Dist	COUNTY	ROUTE	POST MILES TOTAL PROJECT	SHEET No.	TOTAL SHEETS
12	Ora	55	2.0/11.8	5	368

1 REPLACED PER ADDENDUM No. 1 DATED AUGUST 23, 2013

CONSTRUCTION DETAILS
NO SCALE
C-1

CONSTRUCTION DETAILS

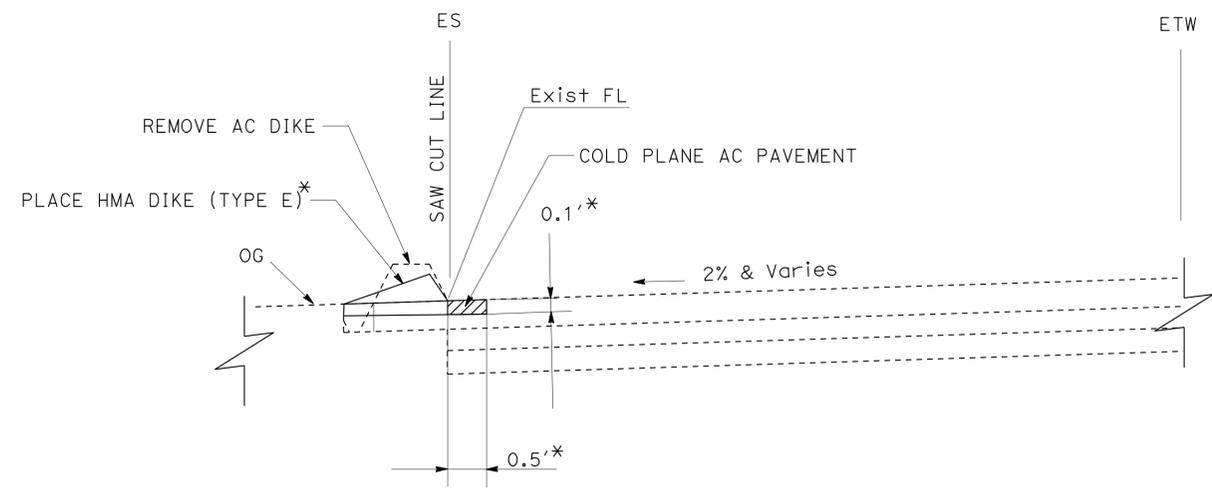
1 REPLACED PER ADDENDUM No. 1 DATED AUGUST 23, 2013

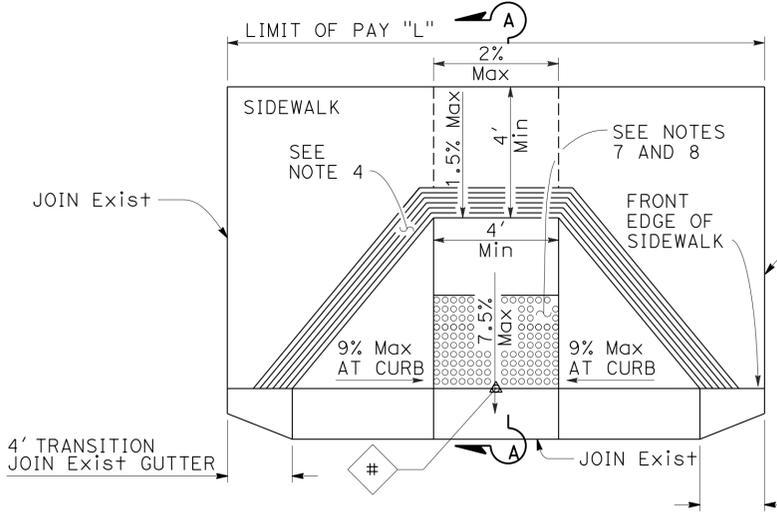
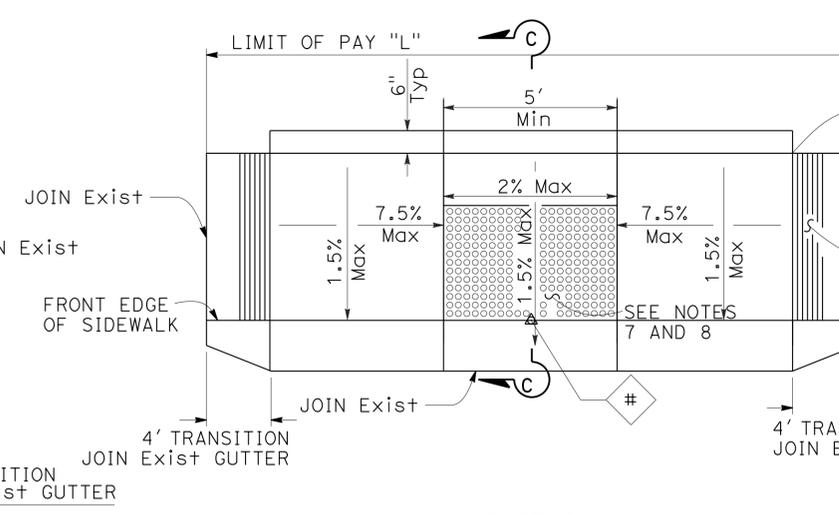
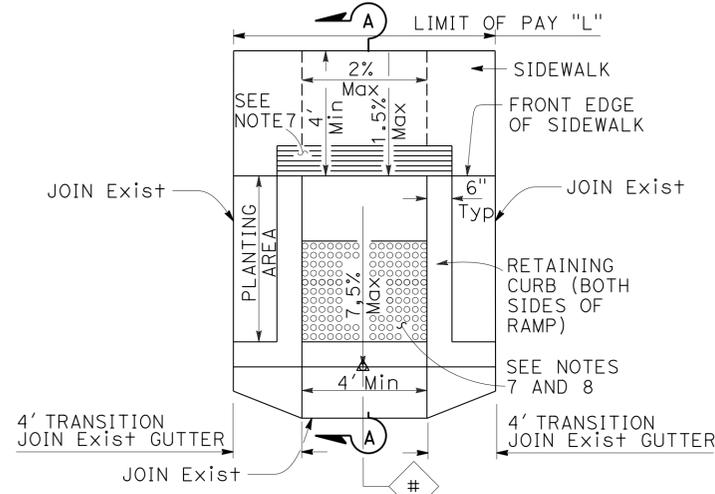
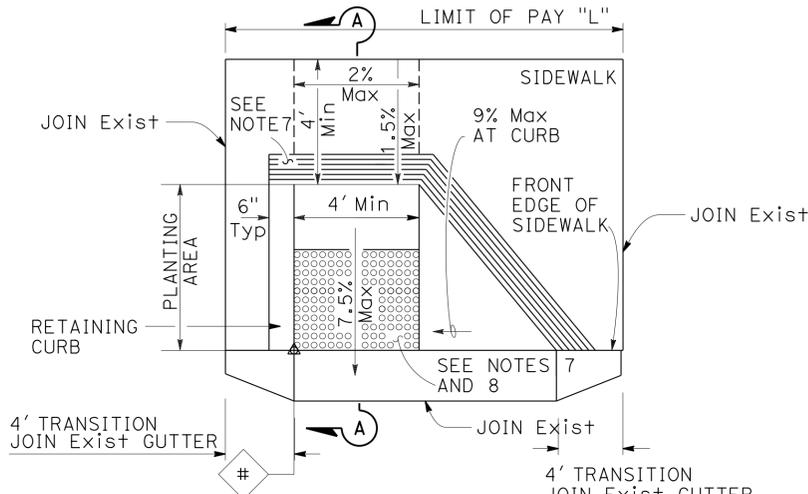
REPLACED PER ADDENDUM No. 1 DATED AUGUST 23, 2013

DETOUR PLAN
 SOUTHBOUND ROUTE 55
 FROM WILSON St/FAIRVIEW Rd TO 19TH St CLOSURE

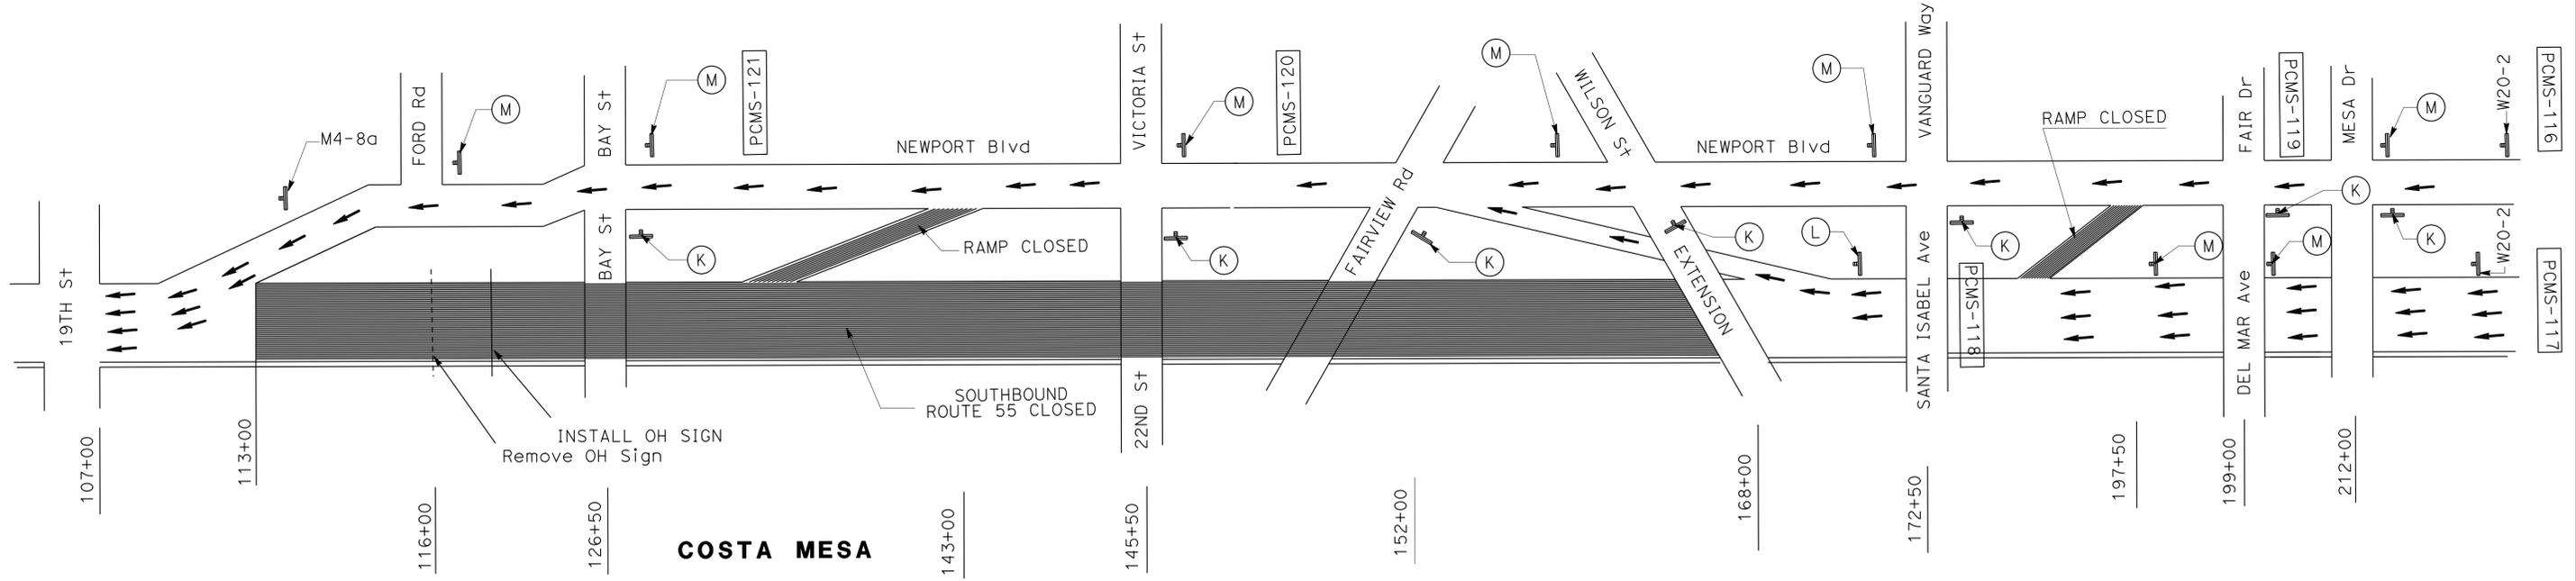
1 REPLACED PER ADDENDUM No. 1 DATED AUGUST 23, 2013
